Annotated Changes Schedule

Proposed Refurbishment Works

Flat 5, 10 Cambridge Gate

HCM/01 – June 19

Proposed Changes – Lounge Area

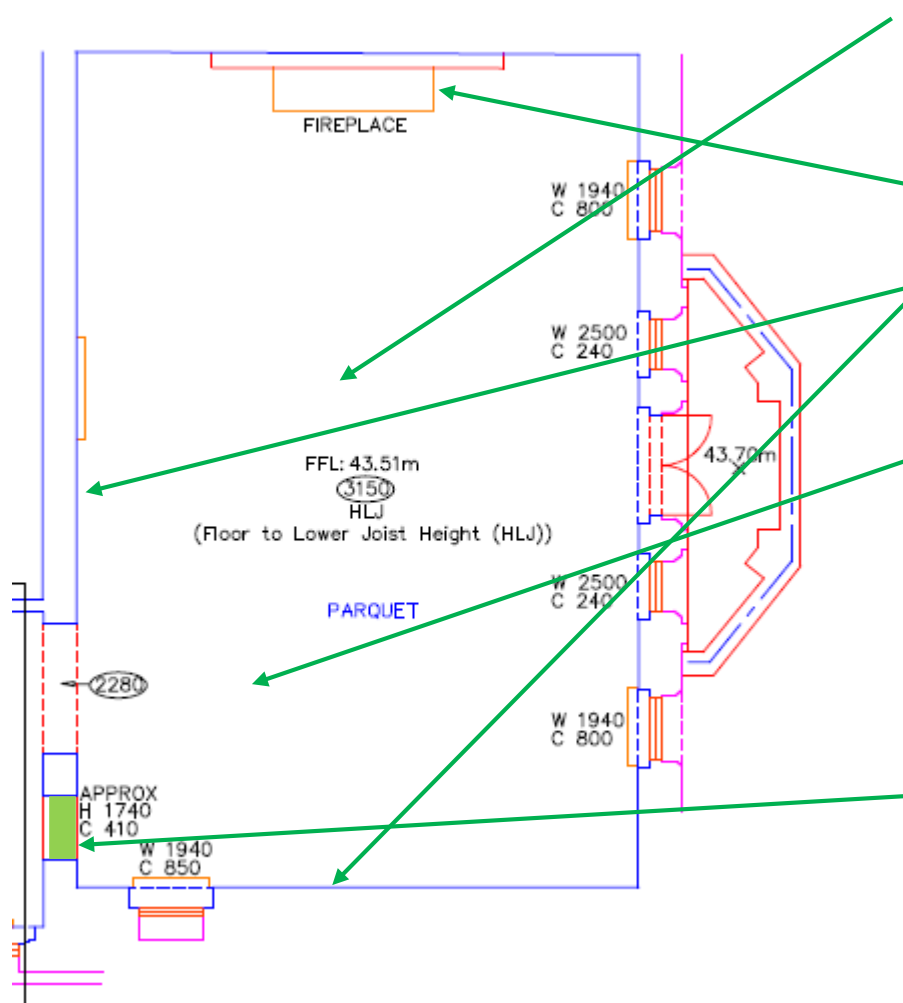
- New parquet flooring to match rest of flat - on acoustic subfloor
- Fireplace to remain
- Add wall panelling to main walls, windows redecorated
- New ceiling and coving – required as fire ceiling required to protect timber joists to flat above
- No structural work or changes to wall layout
- Infill to existing opening – currently a cupboard

Proposed Changes – Kitchen Area

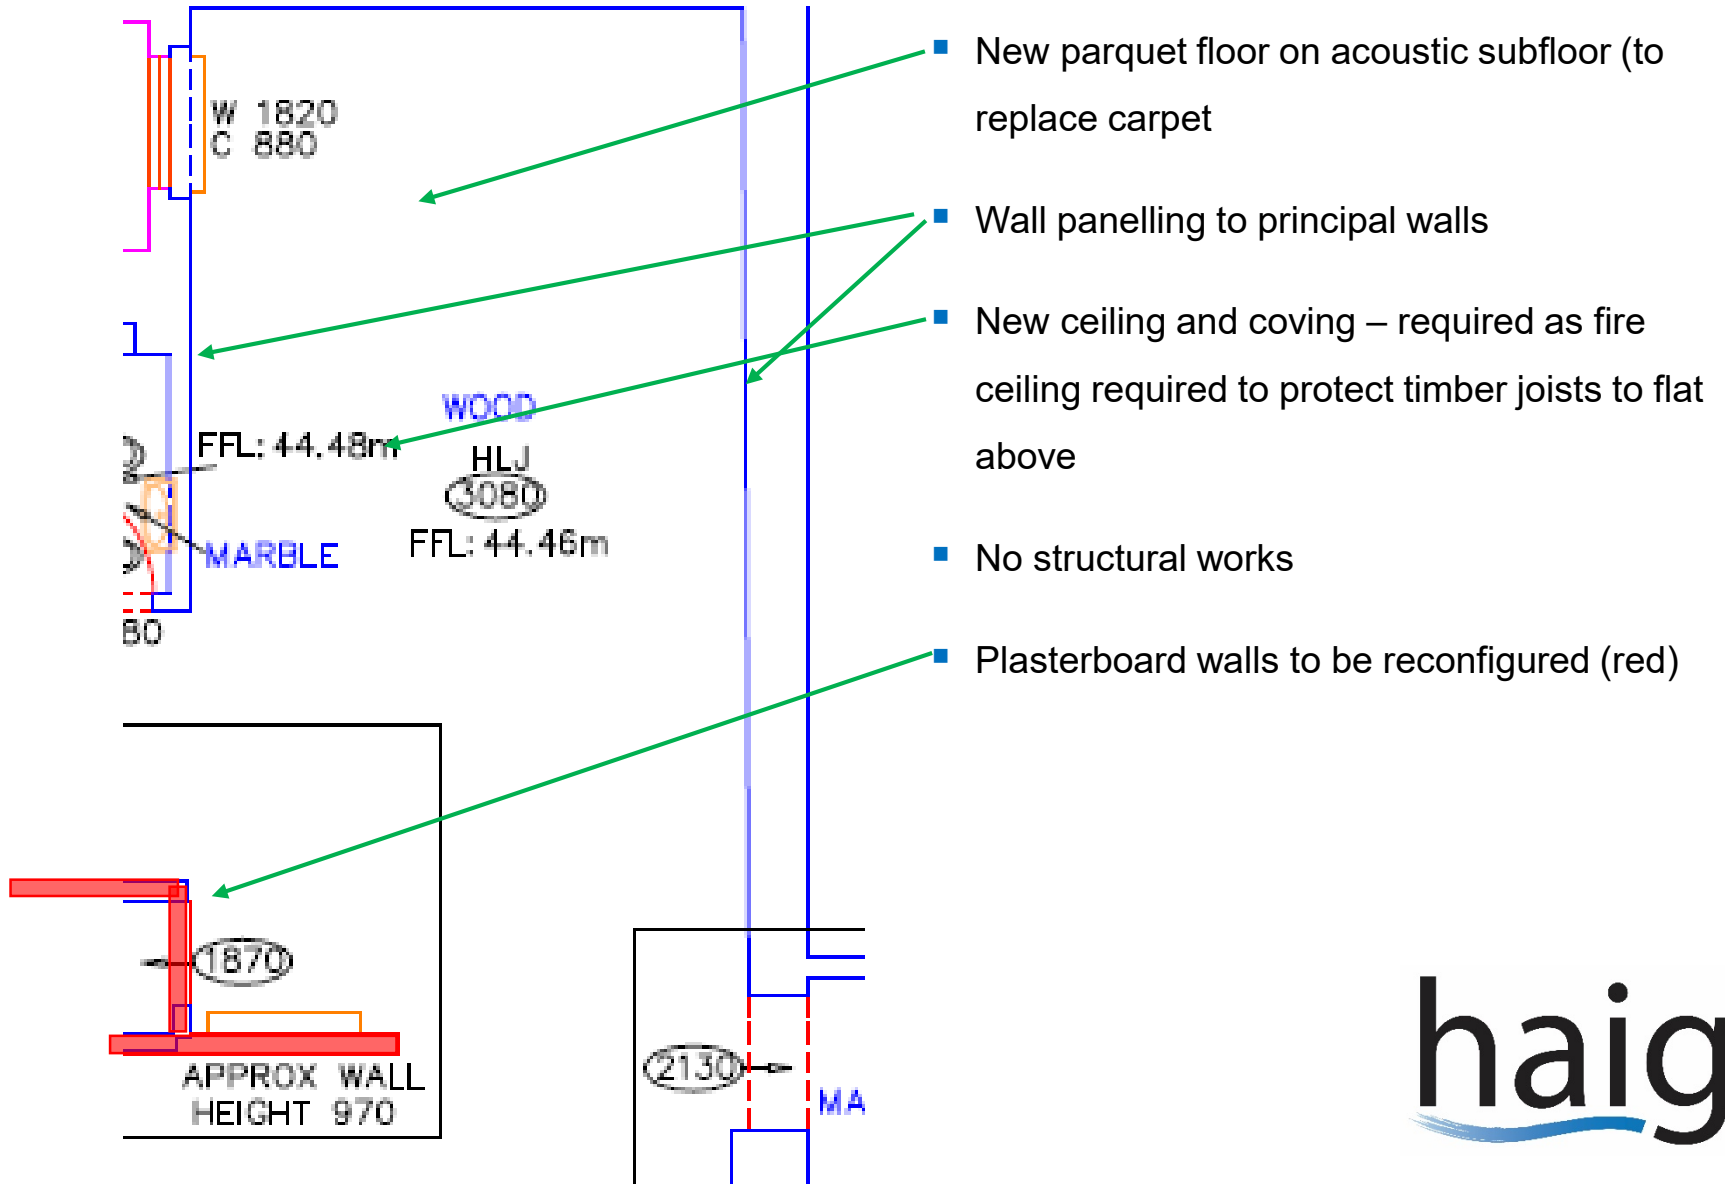
- Plasterboard walls to be reconfigured (red)
- New stone floor in lieu of quarry tiles on acoustic subfloor
- New Kitchen Units
- New ceiling and coving – required as fire ceiling required to protect timber joists to flat above
- No structural works
- New plasterboard wall to kitchen (green)

Proposed Changes – Family Room (was Bedroom 2)

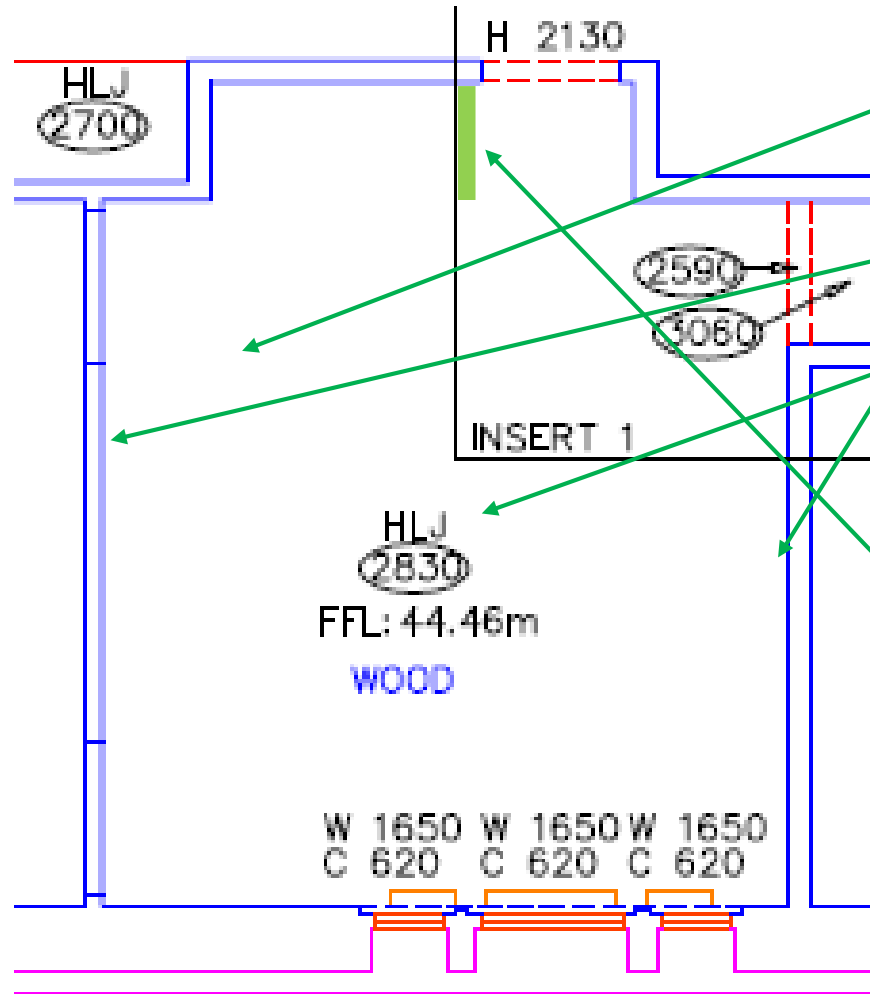
- New Parquet Flooring on acoustic subfloor (to replace carpet)
- Timber wall panelling
- New ceiling and coving – required as fire ceiling required to protect timber joists to flat above
- No structural works
- Plasterboard walls to be added (green)

Proposed Changes – Master Bedroom

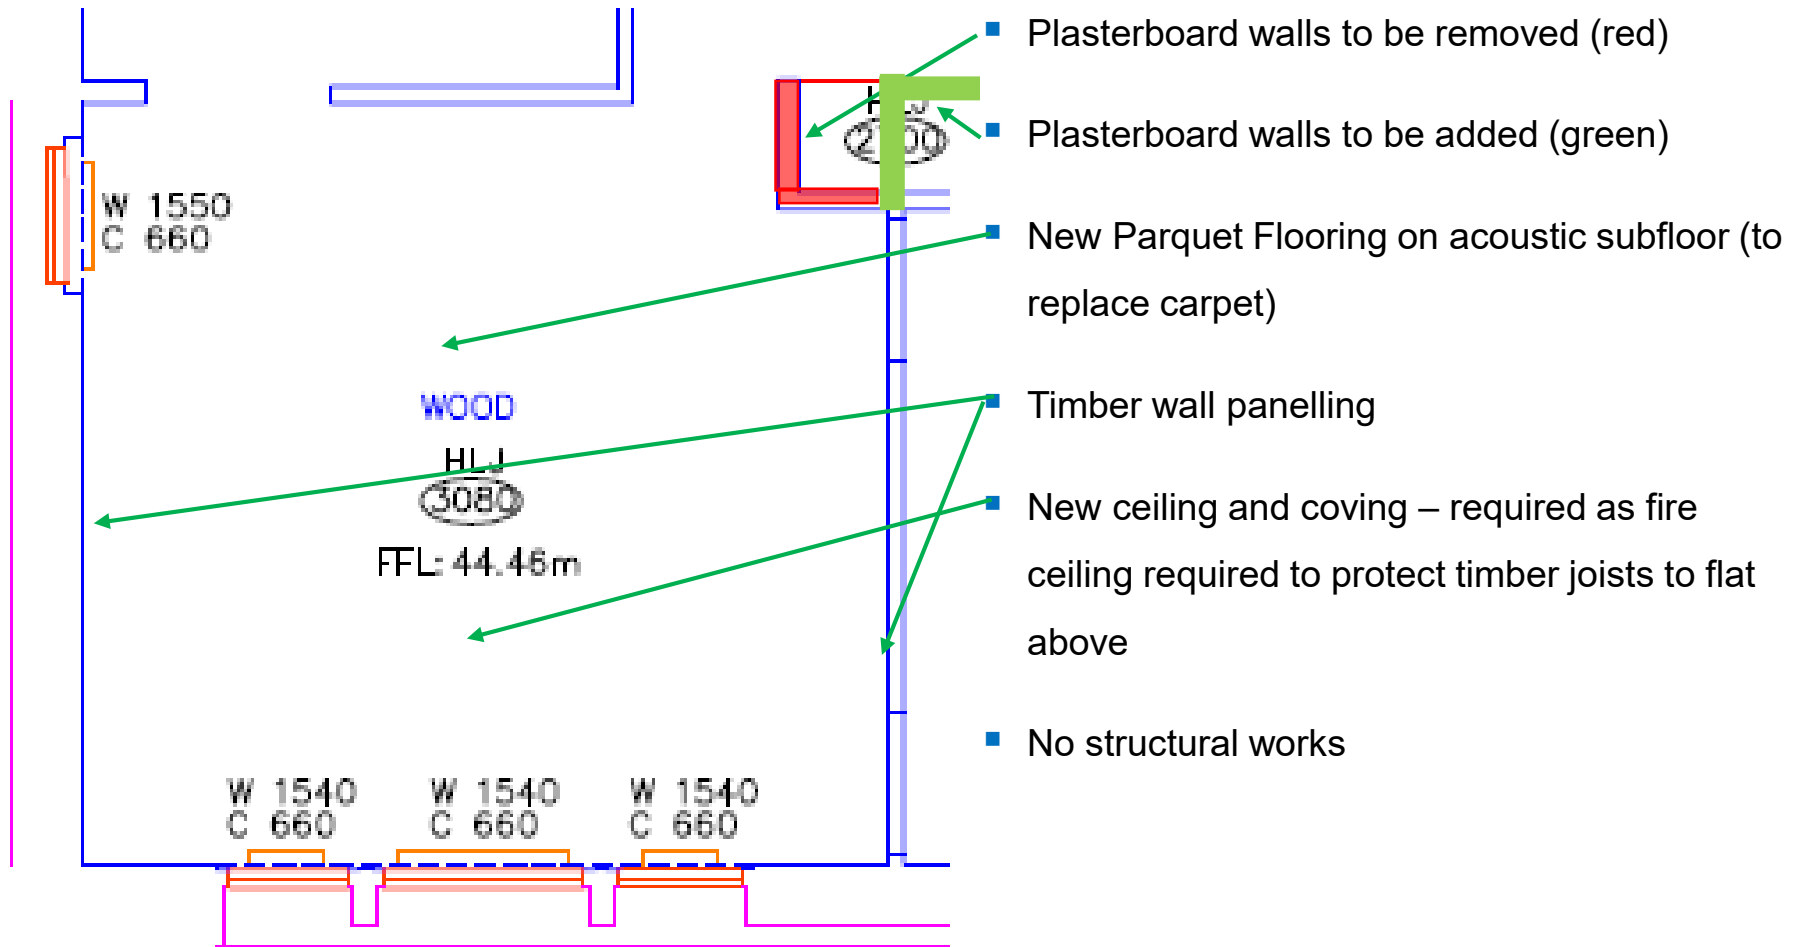
- Plasterboard walls to be removed (red)
- Plasterboard walls to be added (green)
- New Parquet Flooring on acoustic subfloor (to replace carpet)
- Timber wall panelling
- New ceiling and coving – required as fire ceiling required to protect timber joists to flat above
- No structural works
